**ASSESSMENT REPORT
Invincible Colliery
Southern Extension Modification
(07_0127 MOD 5)**

Assessment Report
Section 75W of the
Environmental Planning and Assessment Act 1979

November 2017

Figure 4: Nearby Pagodas and Geo-Diversity Features

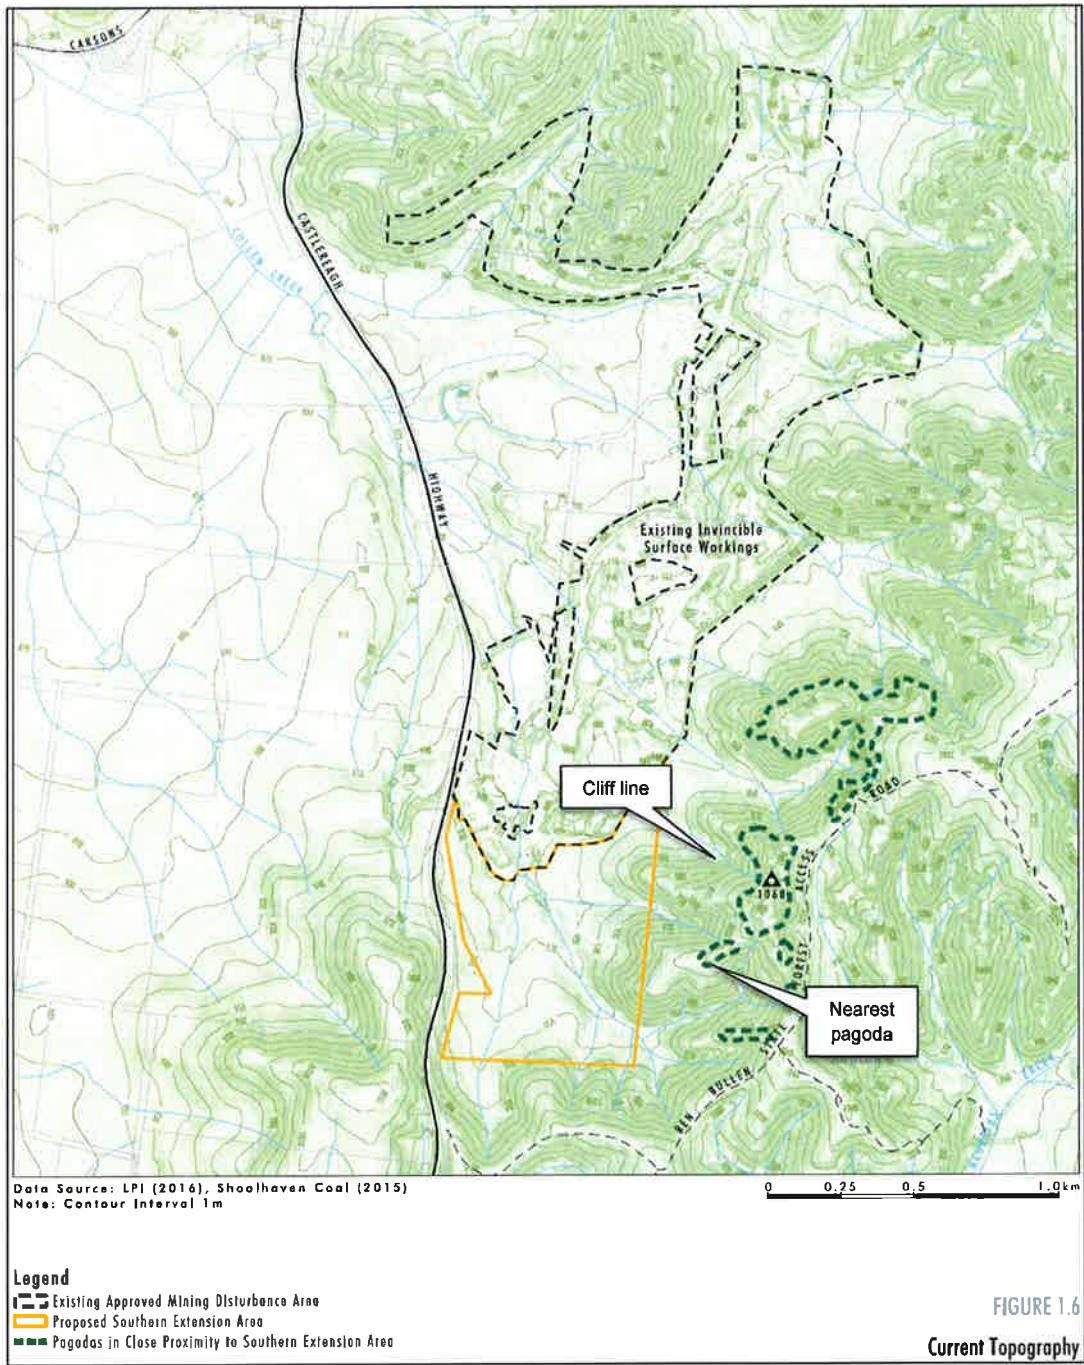
The proposed mine plan includes a buffer of around 210 m between open cut mining associated with the proposal and a pagoda formation to the east of the site, and a buffer of approximately 200 m to an isolated cliff line (see **Figure 4**).

The EA includes a detailed blasting assessment which considers the structural integrity of pagoda landforms and the isolated cliff line, and includes an analysis of damage criteria for sandstone, and other comparative features. In summary, the assessment concludes that blasting impacts could be mitigated by managing ground vibration to 50 mm/s for pagodas and 25 mm/s for the nearby cliff line. These targets would be achieved using an maximum instantaneous charge (MIC) of 175 kg.

Figure 5: Castlereagh's Preferred Conceptual Final Landform (Option 1)

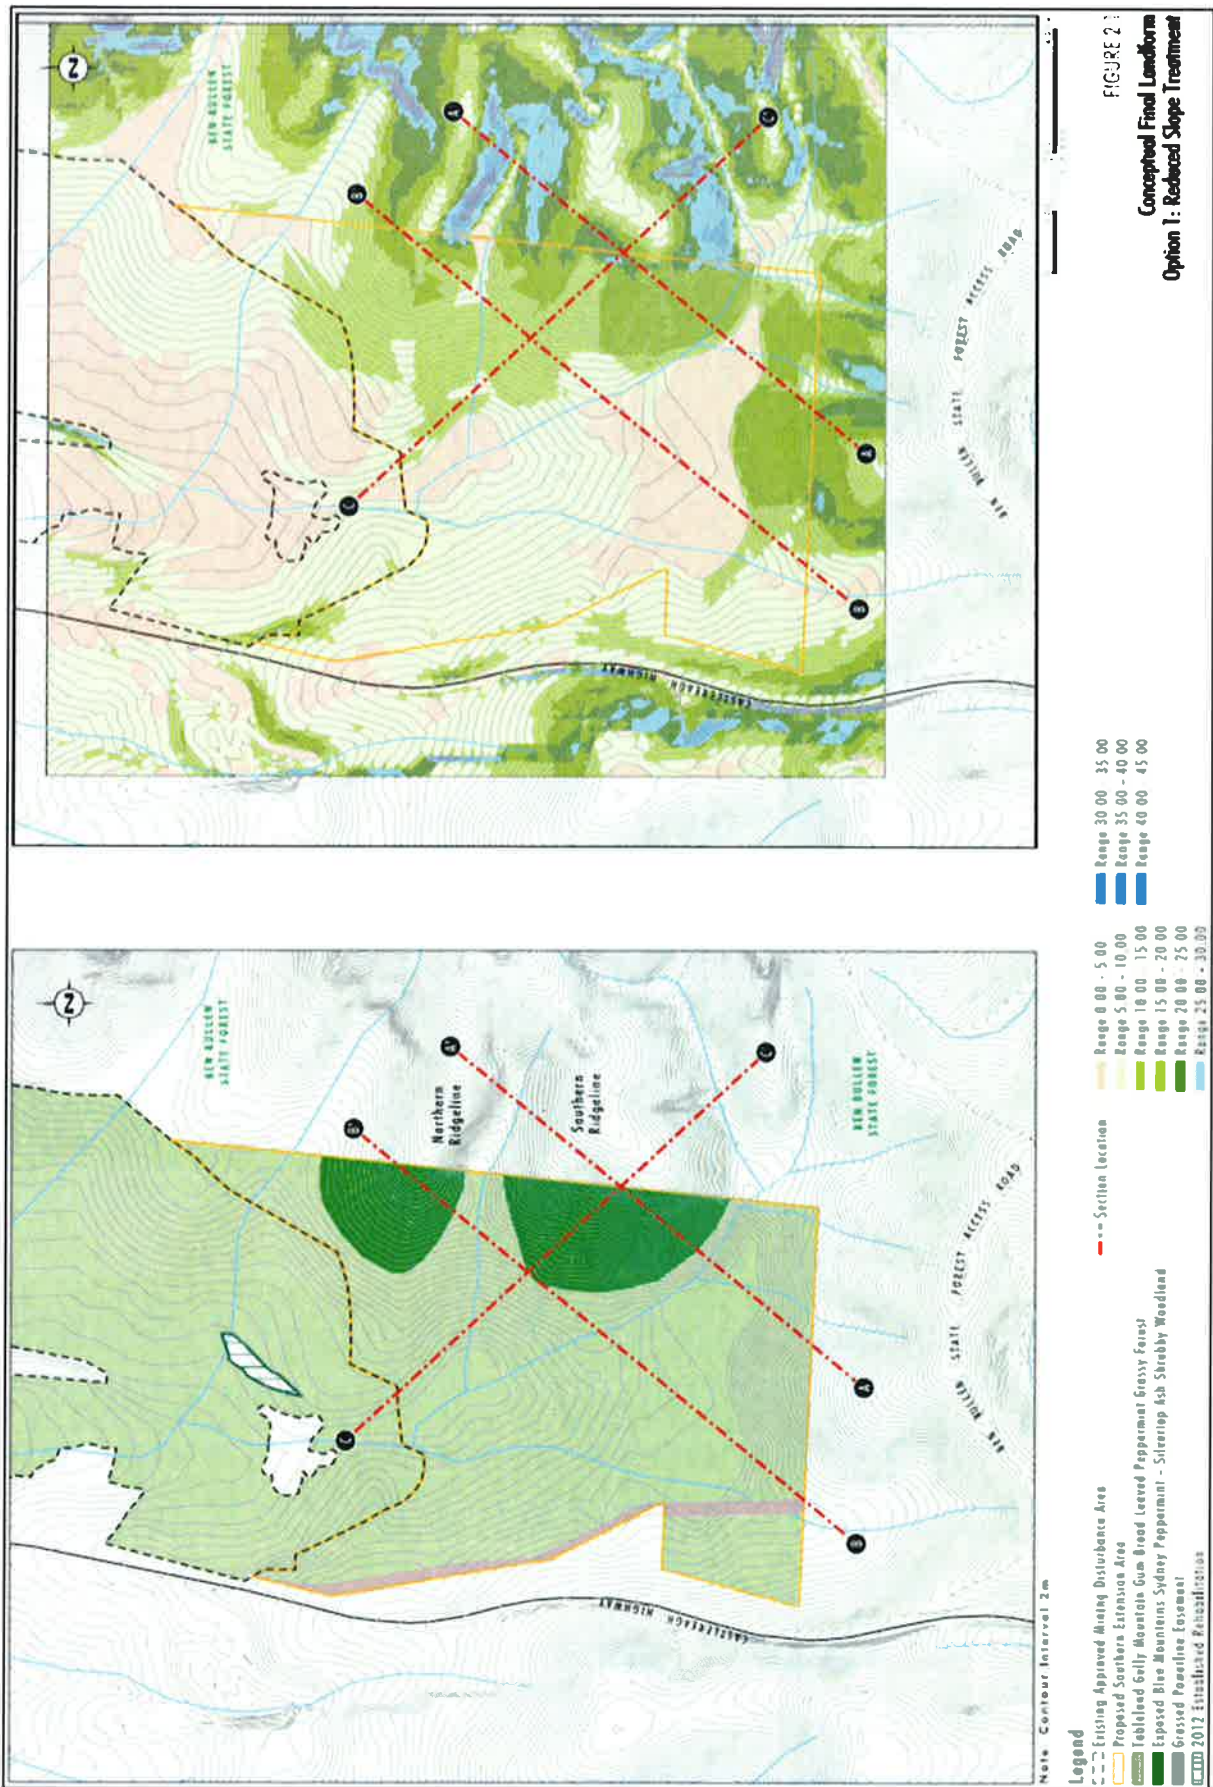
Castlereagh Coal's preferred rehabilitation option (Option 1) for the application is shown in **Figure 5**. This option seeks to reduce the gradient of slopes relative to the rehabilitation strategy presented in the EA (through the use of surplus overburden) and would maximise the benefits of the project (including resource recovery) relative to the alternative rehabilitation options.

Figure 6: Alternate Final Landform Options

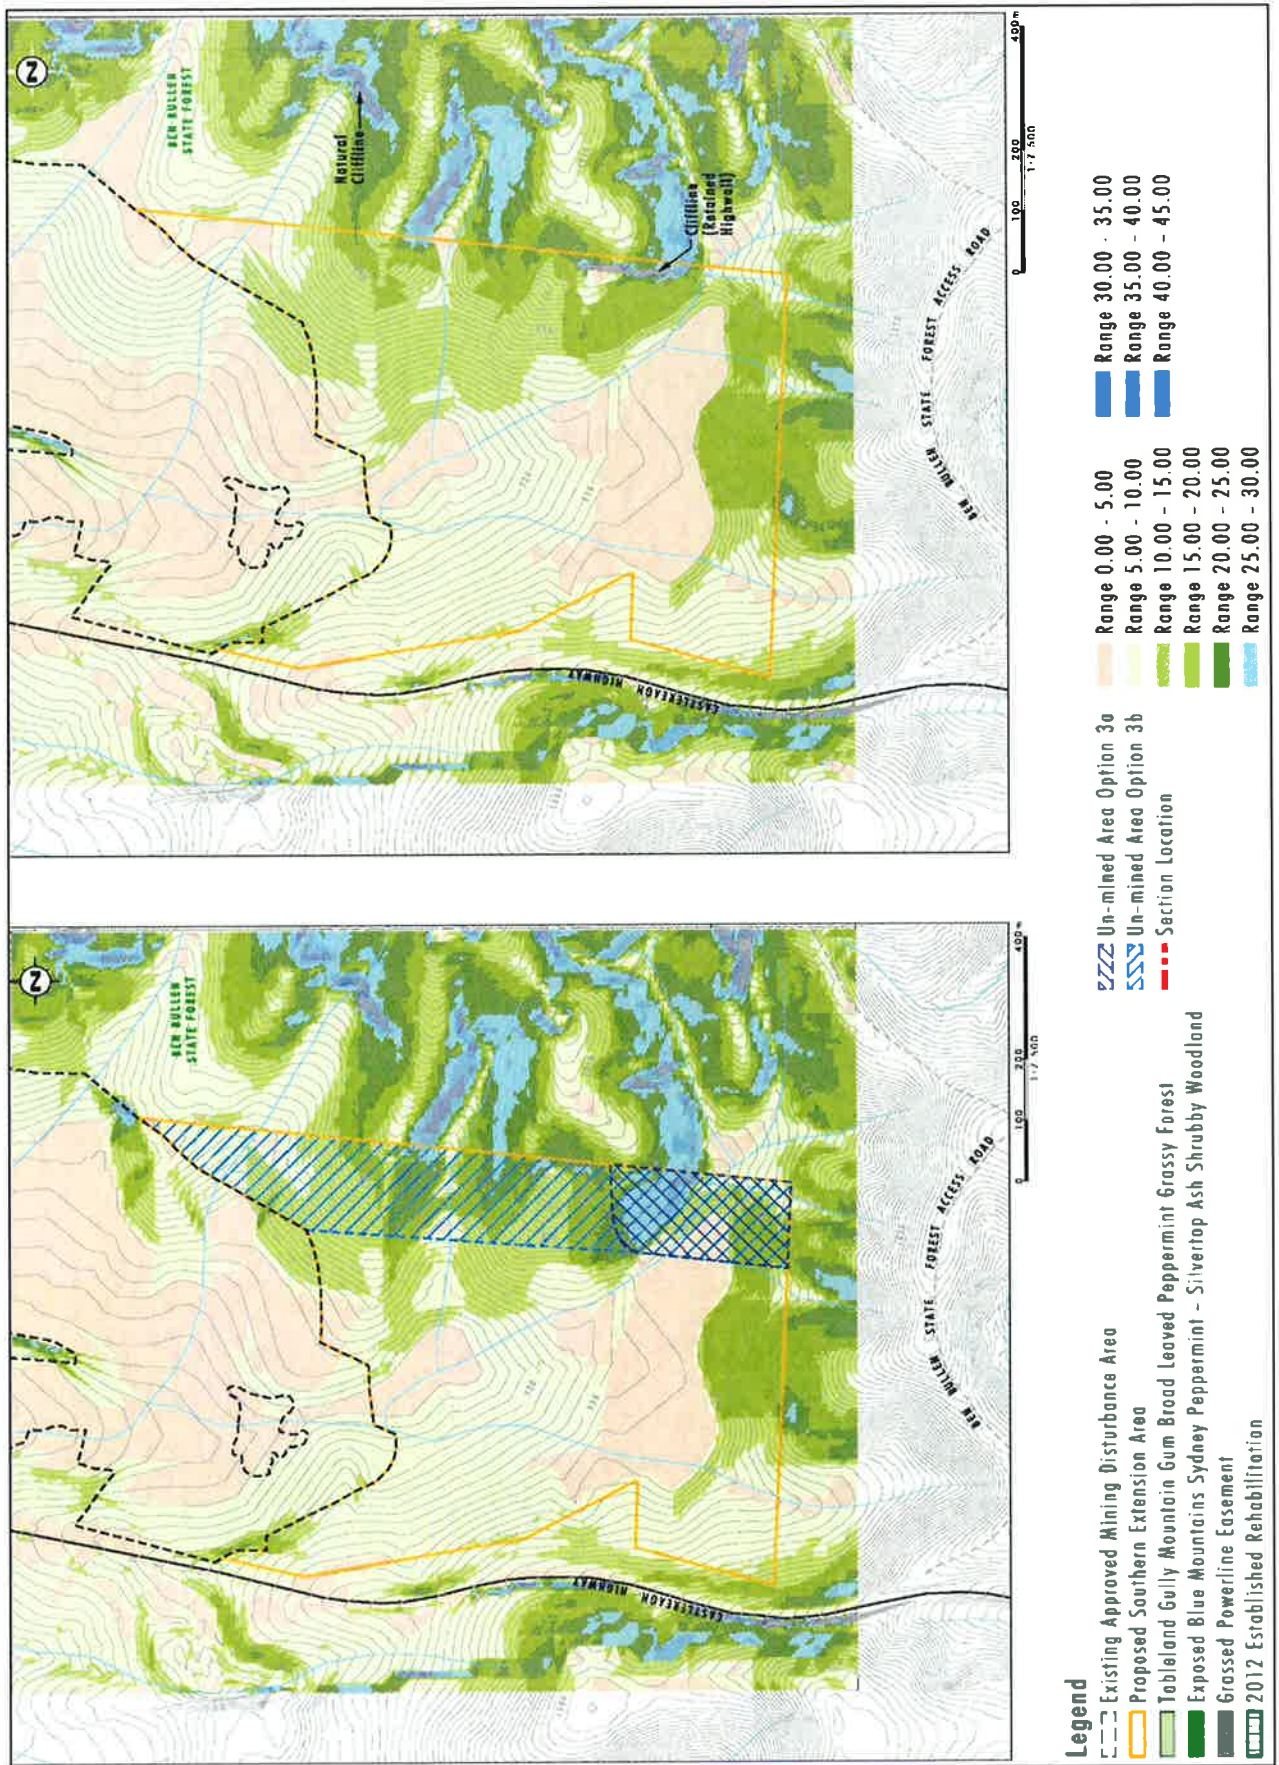
Consequently, the Department has recommended a condition restricting mining operations from being undertaken in the steep areas of the site that are located closer to pagoda formations and the isolated cliff line. The Department's recommendation is consistent with Option 3b provided by Castlereagh Coal in its option analysis for avoiding steep slopes. (see **Figure 6**).

Figure 7: Vegetation Communities

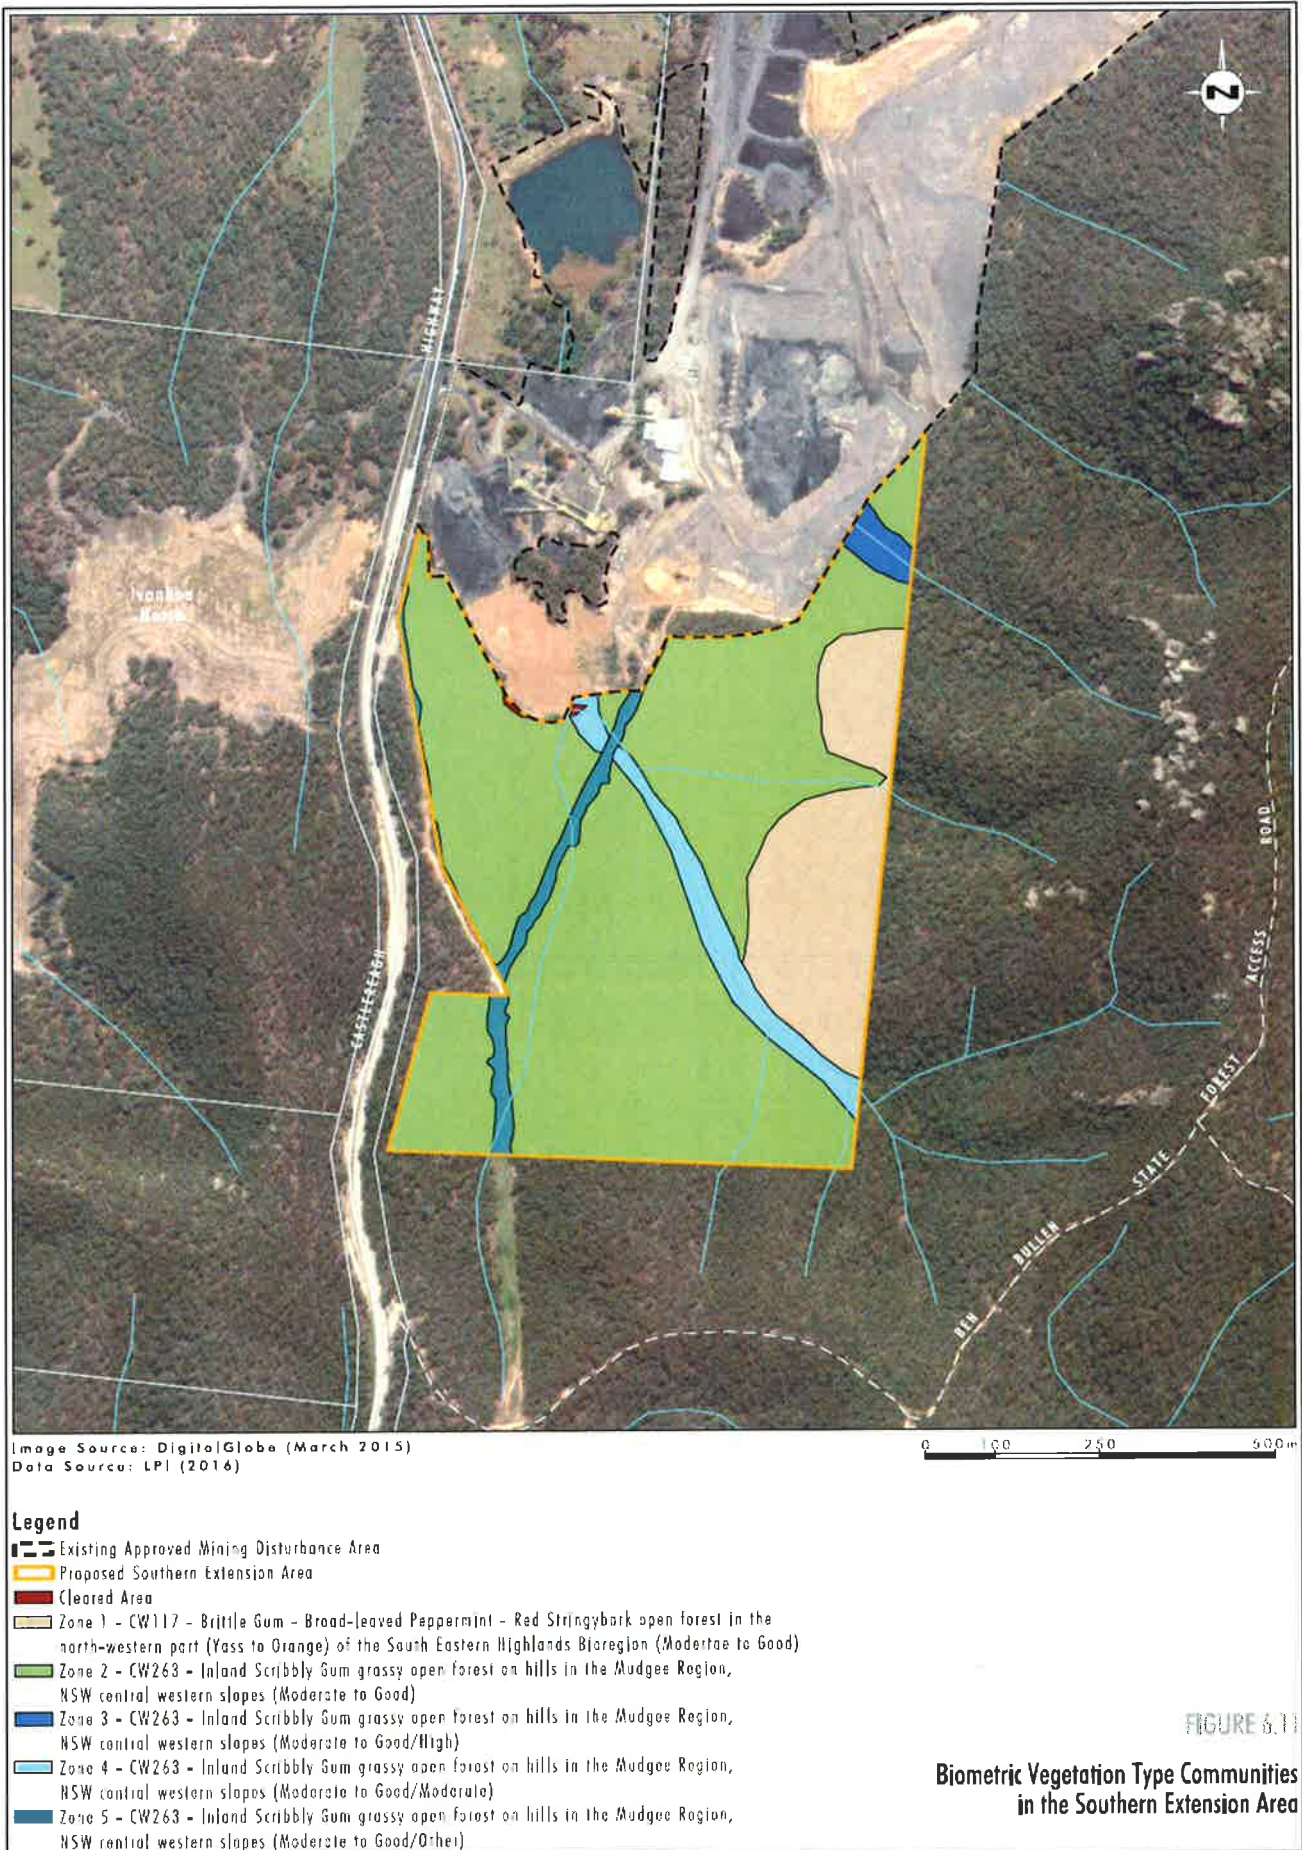
The BAR found that the proposal would result in the disturbance of approximately 50 ha of native vegetation within the Ben Bullen State Forest consisting of 2 biometric vegetation types (BVTs) (see **Table 3** and **Figure 7**).

Figure 9: Underground Workings and Water Management Context

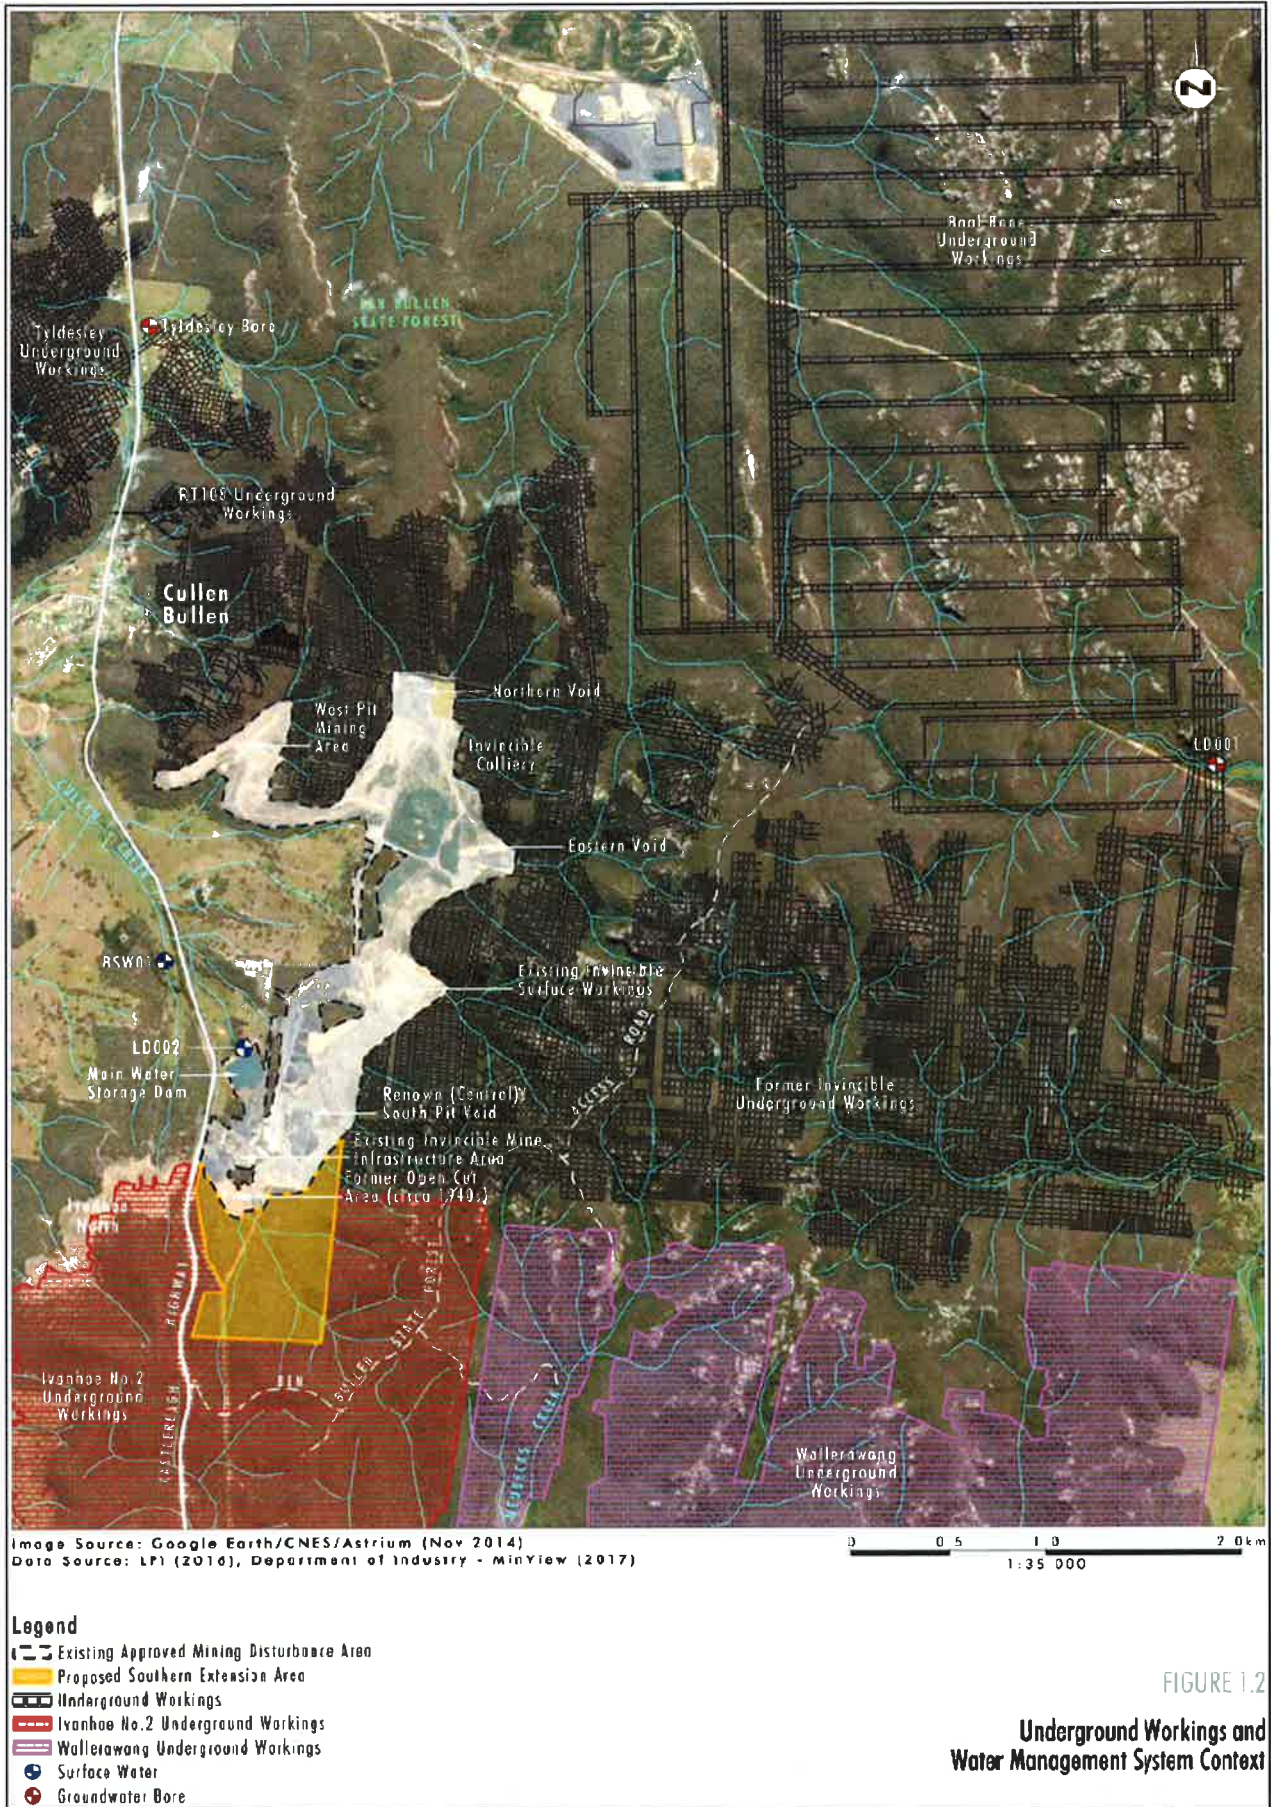
The Invincible Colliery is located in the Cullen Creek catchment which has been subject to a long history of disturbance from forestry, coal mining, extensive agricultural enterprises and construction of infrastructure. There are extensive historical underground mine workings in the vicinity which have had (and continue to have) a major influence on the groundwater regime in the area (see **Figure 9**).
